ITS DISCUSSION OF DIFFERENCES

ITS Section 3.7: Plant Systems

Figure 3.7.1-1 (page 1 of 1)
Reduced Power and Nuclear Overpower Trip Setpoint
versus OPERABLE Main Steam Safety Valves

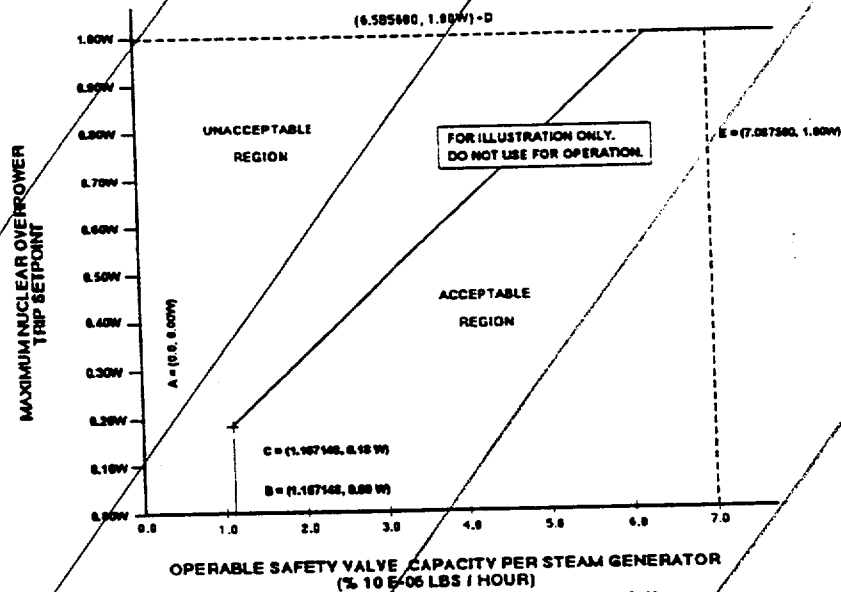
- 1 NUREG-3.7.1 - The main steam safety valves (MSSV) Specification is reformatted to omit the table of specific lift setpoints and to replace the figure for determining the allowable power level and trip settings with predetermined values. The specific lift setpoints are currently required to be tested by current Technical Specification (CTS) Table 4.1-2, item 4. However, the CTS does not contain the specific setpoints. These setpoints are currently identified in the Inservice Testing (IST) Program and are adequately controlled therein under the design change and procedural control programs which include evaluations of changes in accordance with 10 CFR 50.59. Control of these setpoints is proposed to be retained in these programs. A minor editorial change is proposed to clarify that the 1% tolerance is only applicable to the "as-left" settings. The NUREG figure for determining the allowable nuclear overpower-high trip setpoint is provided for units which have MSSVs with different relief capacities. Since it would not be possible to predetermine which valves would be inoperable for the condition, a figure is not provided to calculate the required trip setpoint. However, all MSSVs at ANO-1 are of the same relieving capacity. Therefore, the allowable setpoint for the trip function can be predetermined based on the minimum number of OPERABLE valves per steam generator. This evaluation has been done and provided in a new Table 3.7.1-1, rather than by a figure, for the operators convenience. Also, the wording of Required Action A.1 is revised since the terminology of "reduced power requirement" from the figure is not used in the new Table. The proposed wording is consistent with the wording of Required Action A.2.

The MSSVs shall be OPERABLE ~~as specified in Table 3.7.1-1 and Figure 3.7.1-1~~

Figure 3.7.10-1 (page 1 of 1)
Burnup versus Enrichment Curve for
Spent Fuel Storage Racks

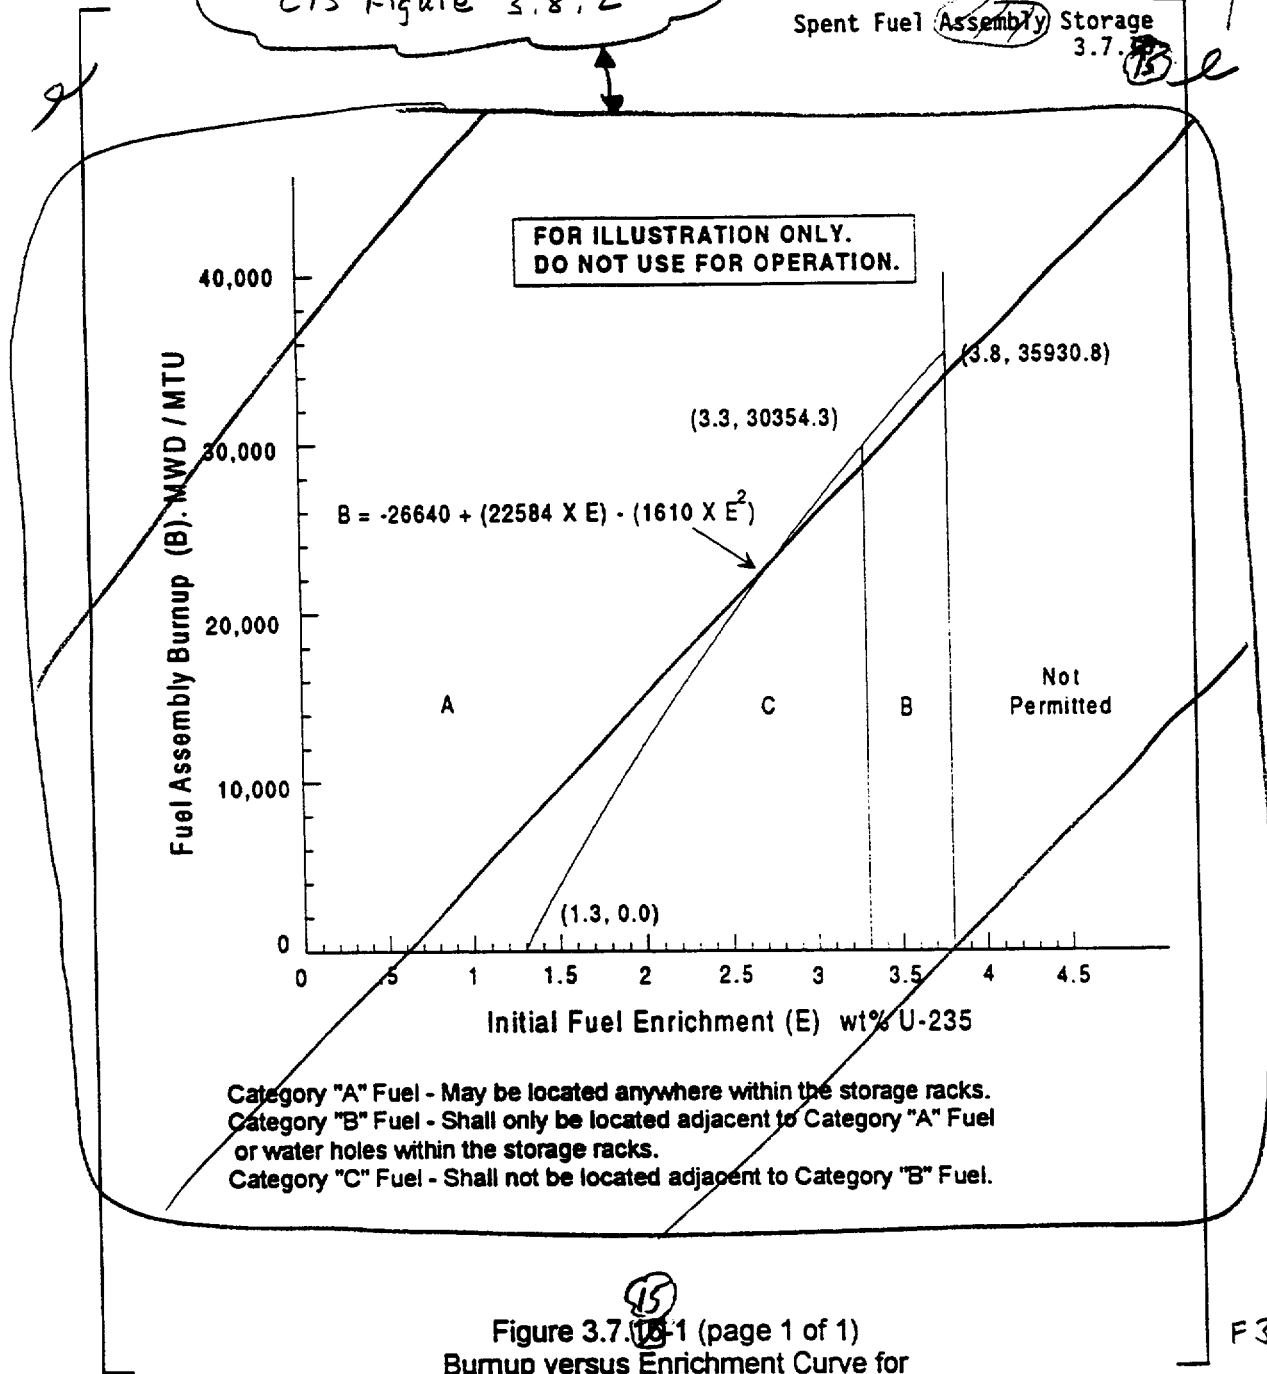
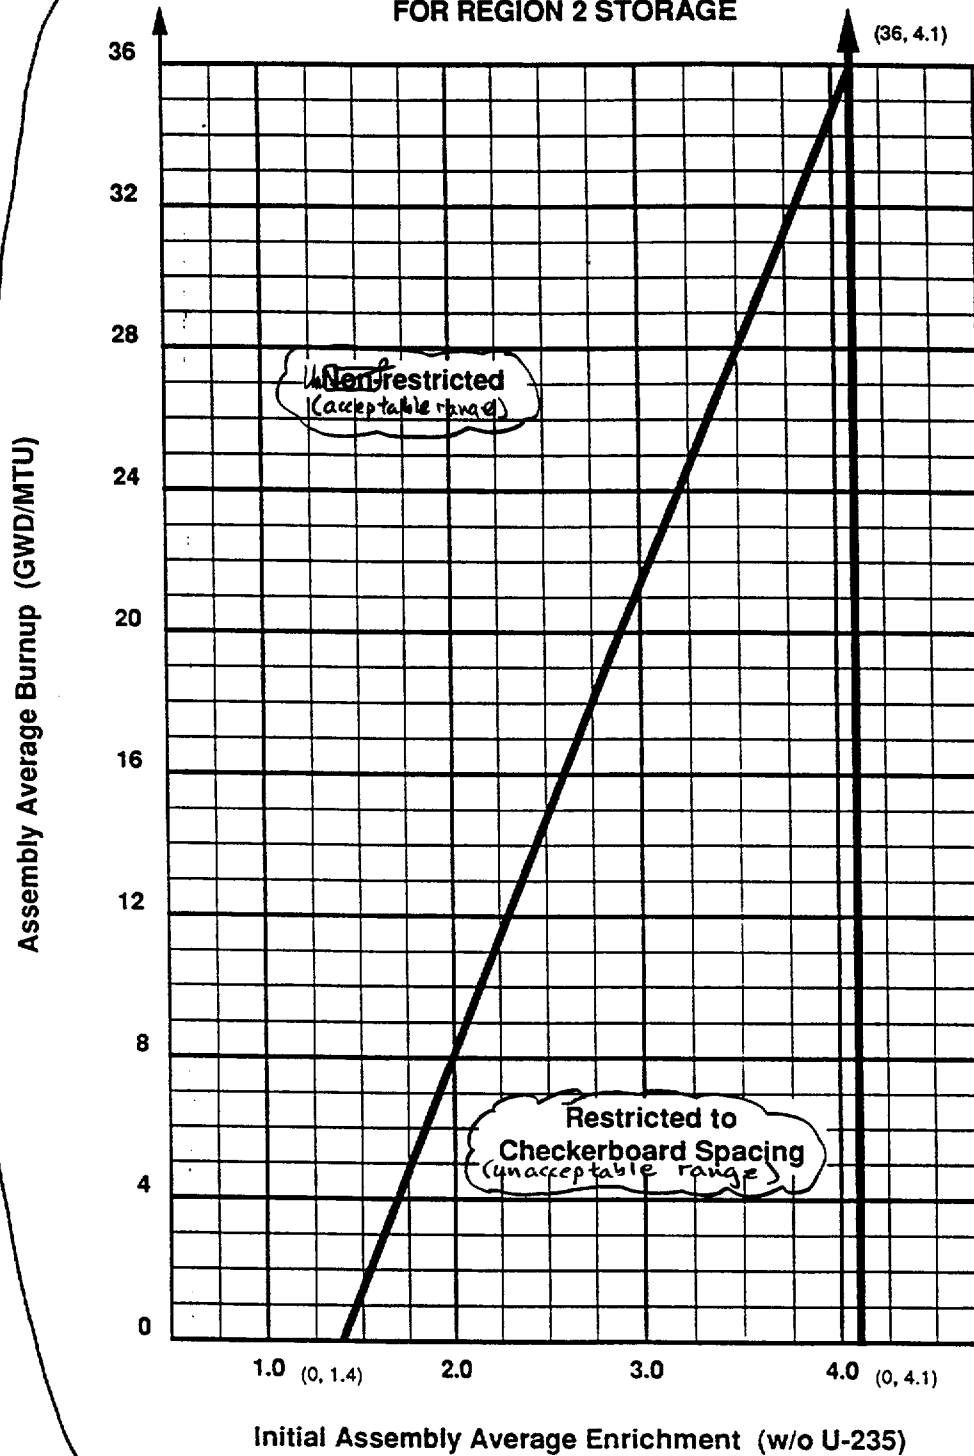
LCO 3.7.15 The combination of initial enrichment and burnup of each spent fuel assembly stored in Region 2 shall be within the acceptable ^{burnup domain} of Figure 3.7.15-1 or in accordance with Specification 4.3.1.1. ^{range}

Replace with AND-1
CTS Figure 3.8.2

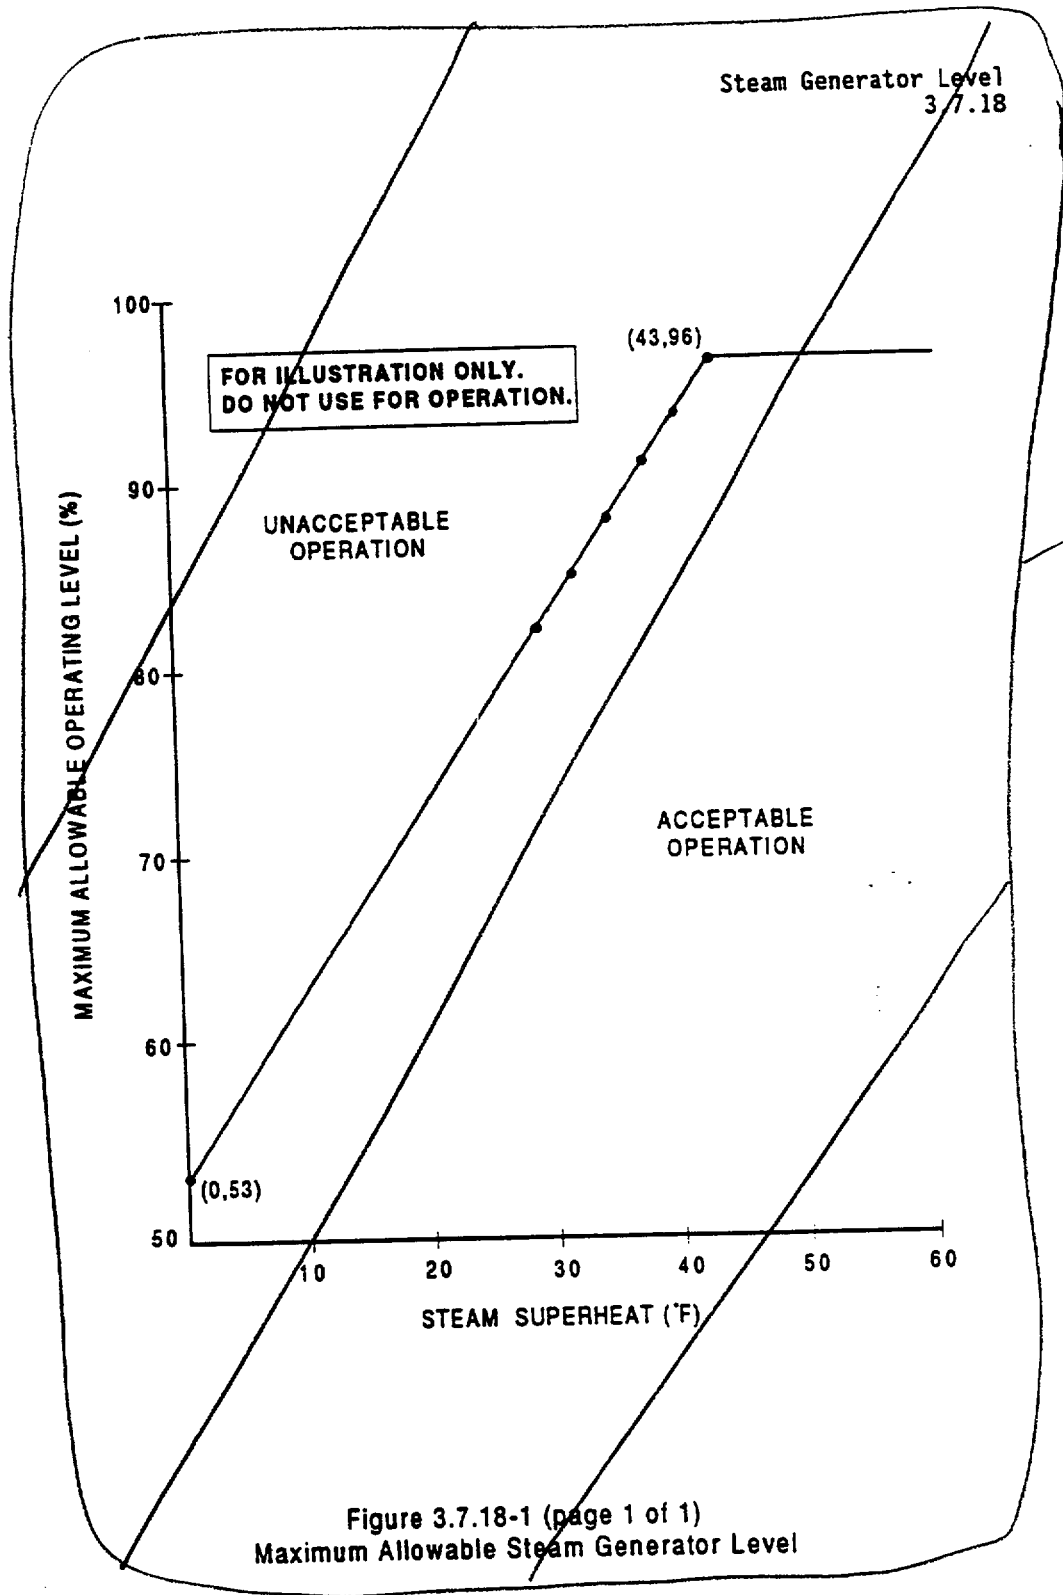
- 38 NUREG 3.7.18 - The unit safety analysis does consider a steam generator inventory; however, the inventory assumed in the analysis for a main steam line break is conservatively considered to be well above the level at which the steam generator aspirator ports would be flooded. Administrative controls have been sufficient to assure compliance with the safety analysis assumption, and an upper steam generator level is not included in the CTS. Therefore, the controls for these valves are proposed to continue to be administrative and not incorporated in the ITS. This change is consistent with current license basis.
